Your ref
APP/20/00761

Our ref
PLAN-035139

Proposal: Erection of a 64 bed older persons care home (Use Class C2) together with construction of new access road, car/cycle parking, drainage works, hard/soft landscaping and other associated infrastructure.

Site: APP/20/00761: - Land on the East side of Helmsley House, Bartons Road, and West of Normandy Road, Havant PO9 5NB.

O.S. REF: SU7307NW

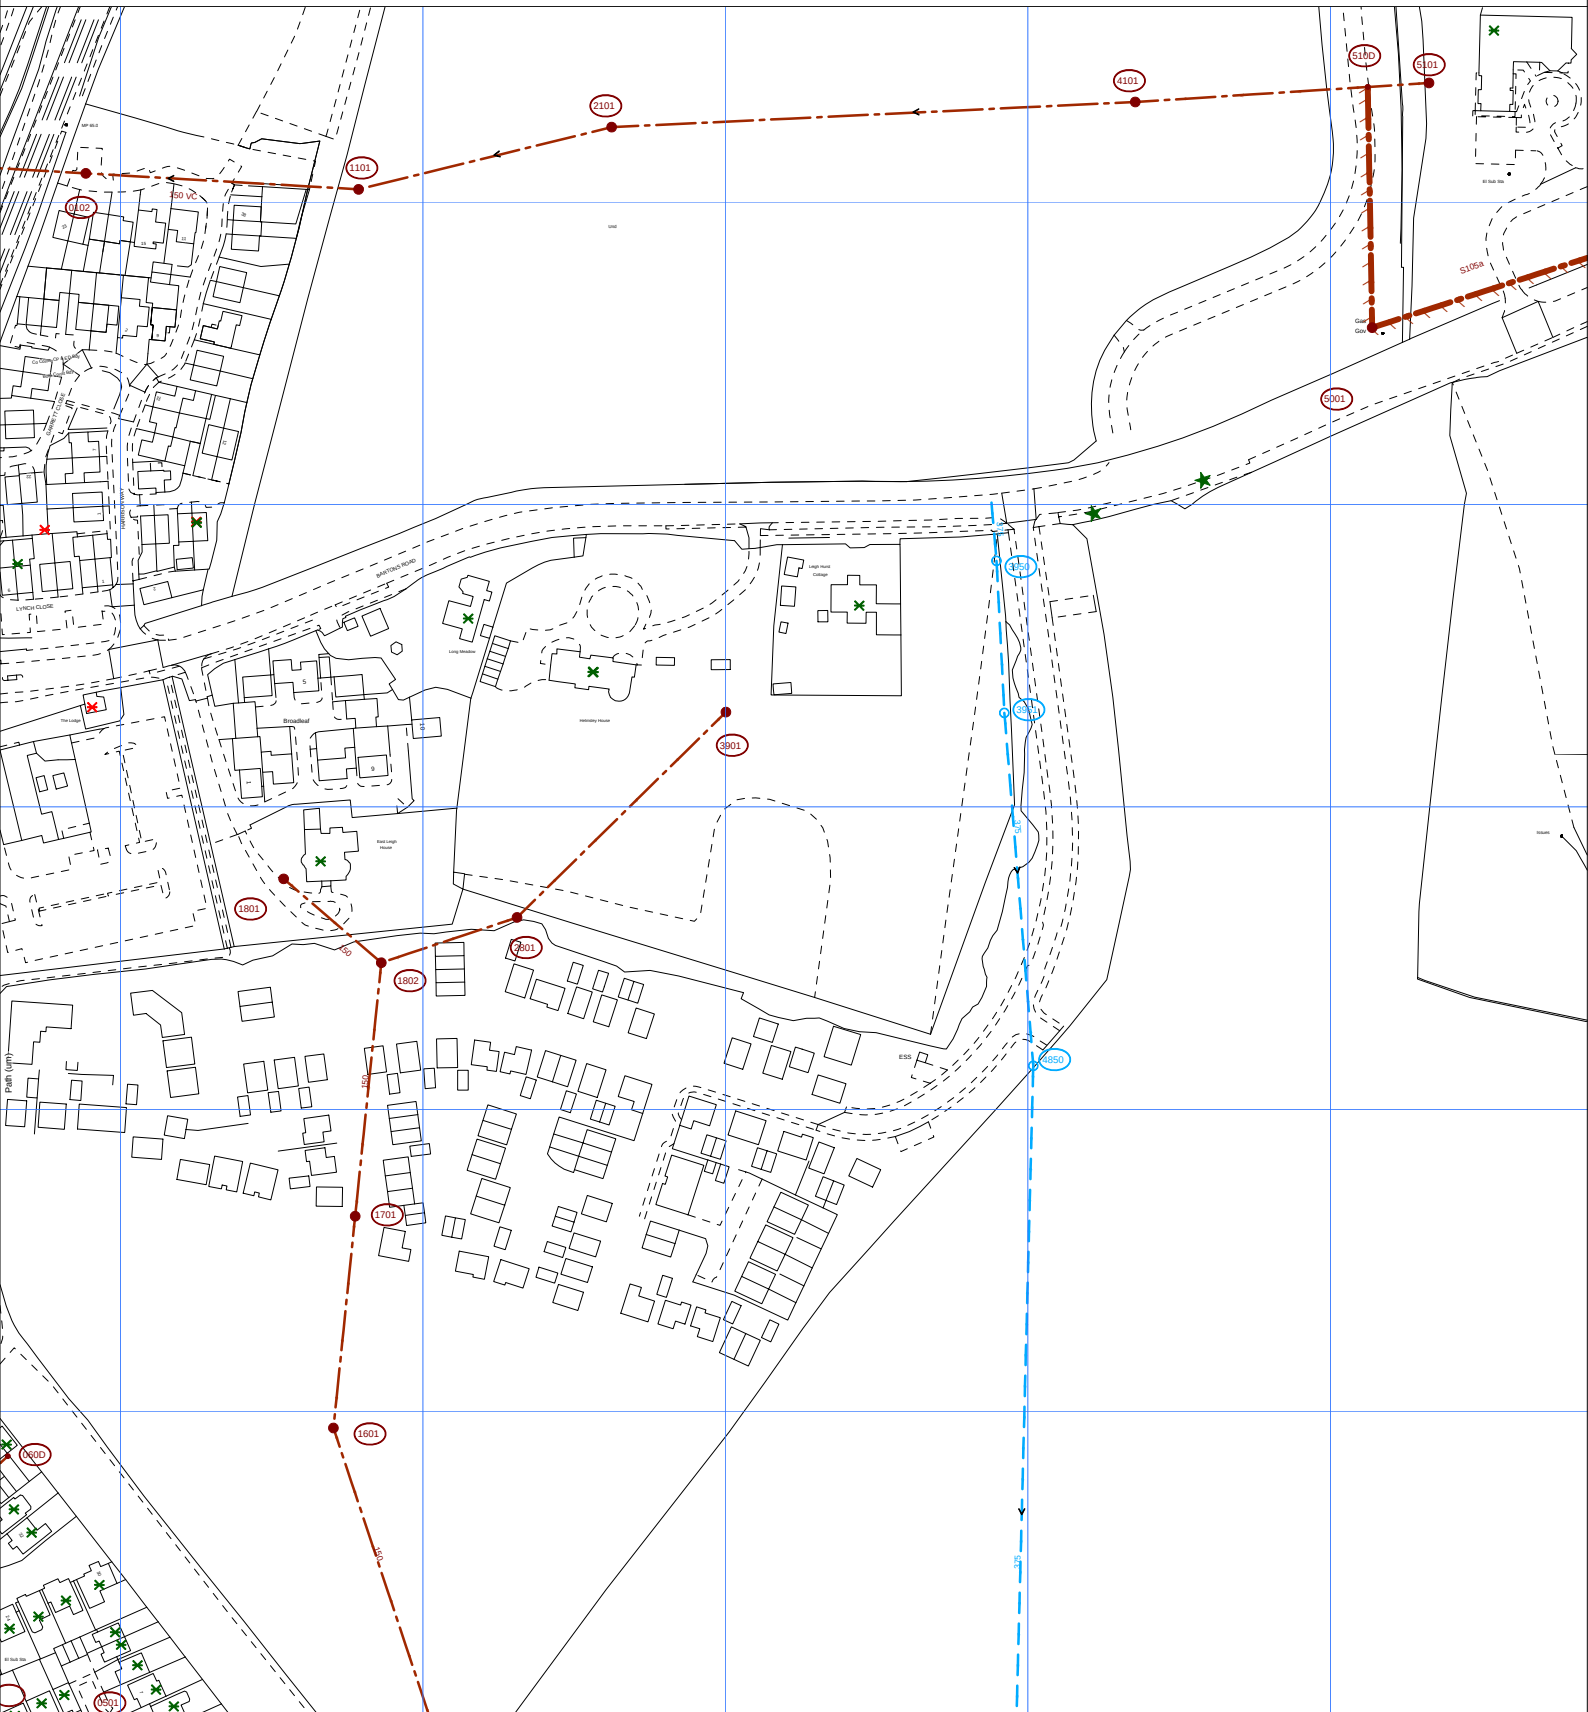
Please see the attached extract from Southern Water records showing the approximate position of our existing public surface water sewer within the development site. The exact position of the public foul sewer asset must be determined on site by the applicant in consultation with Southern Water.

- The 375 mm public surface water sewer requires a clearance of 3 metres on either side of the gravity sewers to protect it from construction works and to allow for future access for maintenance.
- No development or tree planting should be carried out within 3 metres of the external edge of the public sewer without consent from Southern Water.
- No soakaway, swales, ponds, watercourses or any other surface water retaining or conveying features should be located within 5 metres of public sewer.
- All existing infrastructure should be protected during the course of construction works.
